UNITED STATES PATENT AND TRADEMARK OFFICE

APPLICATION NO.	FILING DATE	FIRST NAMED INVENTOR	ATTORNEY DOCKET NO.	CONFIRMATION NO.
10/718,530	11/24/2003	Helmut Schwartz	P24417	1995
7055	7590	03/02/2006	EXAMINER	
GREENBLUM & BERNSTEIN, P.L.C. 1950 ROLAND CLARKE PLACE RESTON, VA 20191			MITCHELL, KATHERINE W	
			ART UNIT	PAPER NUMBER
			3677

<p align="center">Office Action Summary</p>	<p>Application No.</p> <p>10/718,530</p>	<p>Applicant(s)</p> <p>SCHWARTZ ET AL.</p>	
	<p>Examiner</p> <p>Katherine W. Mitchell</p>	<p>Art Unit</p> <p>3677</p>

Fig.1**Fig.3**

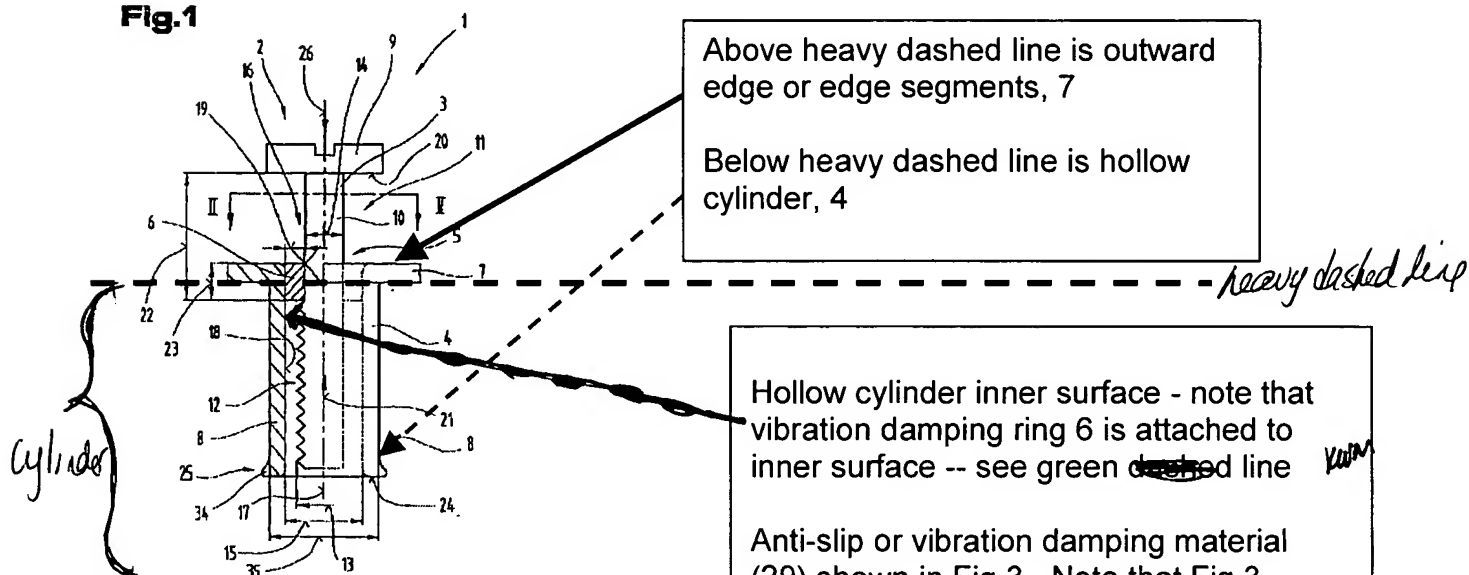
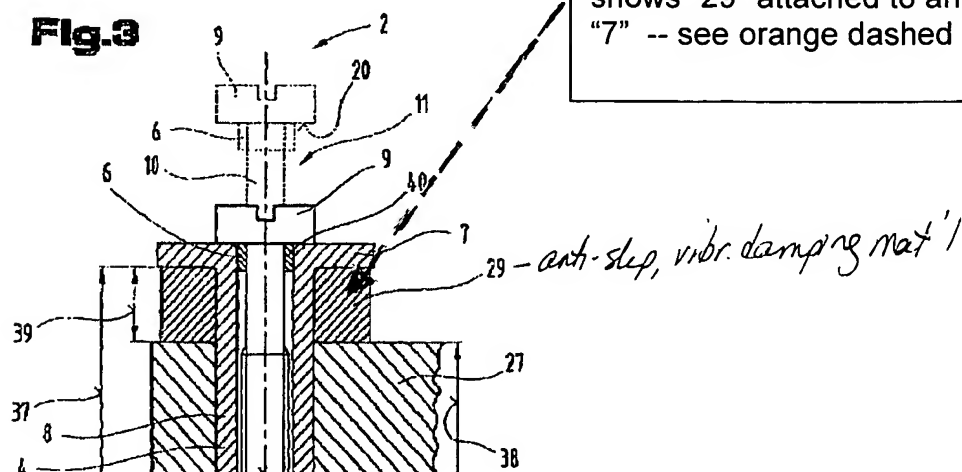
Re claim 1: Radtke teaches a vibration damping ring inert arrangement comprising: A vibration damping ring(6). Note that while examiner refers to embodiment Fig 1-3, ring (6) is the same in both embodiments as described in para. [0029, 0040].

- A hollow cylinder (4) with 1st and 2nd ends and an inner surface connected to the outer surface of the ring
- An outwardly extending edge 7 arranged at the 2nd end (flange-like projection 7 in Fig 1 and 3.)
- Anti-slip or vibration damping material (29) attached to an annular surface of the edge or edge segments, either of which are outwardly extending.

Re claim 9: The outwardly extending edge is substantially perpendicular to an axis (17) running through the cylinder.

Re claim 37: Part 27 and part 28 are coupled via the vibration damping insert arrangement per Fig 3 and paras [0031] and [0037]. Note that “through-opening” was not claimed.

FIG. 2

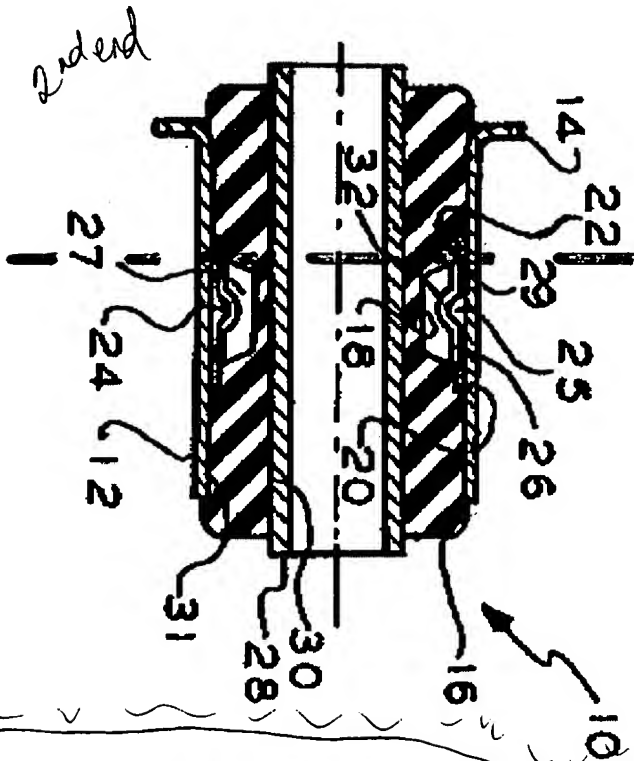
- A vibration dampening ring (16, lower part at and below encircling ring 22 as oriented in Fig 2 below)), col 3 line 64-col 4 line 40.
- A hollow cylinder (12) with 1st and 2nd ends and an inner surface connected to the outer surface of the ring (16, lower part)
- An outwardly extending edge arranged at the 2nd end (14, Fig 2.)
- Anti-slip or vibration damping material (16, upper part above encircling ring 22 as oriented in Fig 2 below) attached to an annular surface of the edge or edge segments, either of which are outwardly extending. Also, note that “ring” and “material” are not equivalent terms, and thus the vibration damping ring can be considered to be the entire unit “16”, made in its entirety of the anti-vibration or anti-slip material – the “ring” element can also be the “material” composition.

Interpretation 1:

anti-slip or vibration damping material
is above blue line

— blue dashed line

vibration damping ring, below
blue dashed line.

FIG. 2

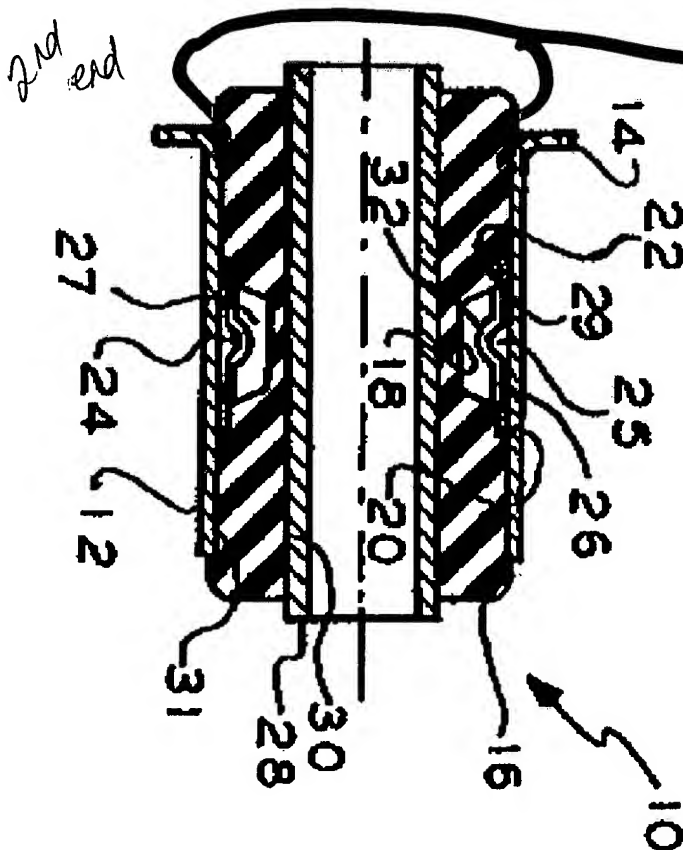
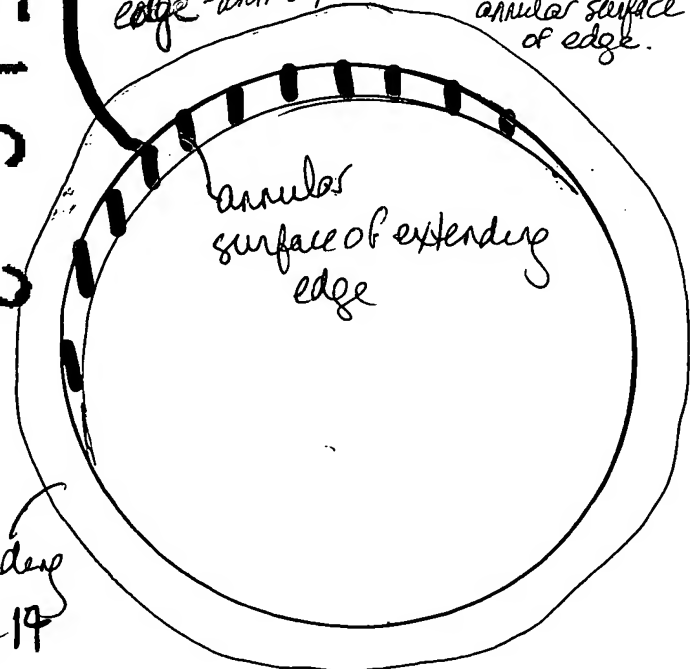
Interpretation 2:

entire elastomeric cylinder 16 is
vibration damping ring, made of
anti-slip, vibration damping material

Red vertical line - represents
annular surface of extending
edge - anti-slip material attached to
annular surface
of edge.

extending
edge 14

Re claim 9: The outwardly extending edge is substantially perpendicular to an axis (Fig 2) running through the cylinder.

Re claims 10-12 and 47: Fig 2 shows the vibration-dampening ring having 1st and 2nd annular projection portions extending beyond the respective ends of the hollow member by an equal given amount. Note that in this situation, the vibration damping ring is considered the entire element "16", and the anti-slip and vibration-damping material is the material that the ring is made from.
